<b>IOWA DOT</b>	REVISION	
	2	04-19-16
<b>STANDARD ROAD PLAN</b>		<b>SI-182</b>
		SHEET 1 of 1

**PERMANENT ROAD CLOSURE -  
URBAN**

**END OF ROADWAY MARKER FABRICATION**

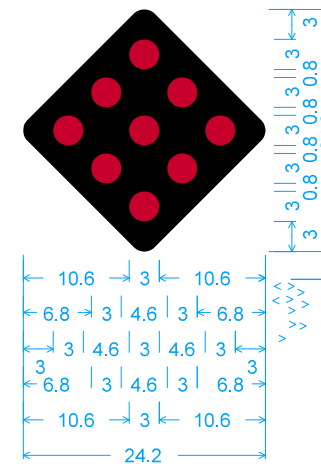
REVISIONS: Removed OM4-1 and OM4-3 from END OF ROADWAY MARKER FABRICATION detail. Revised note 3 and APPROACH VIEW detail.
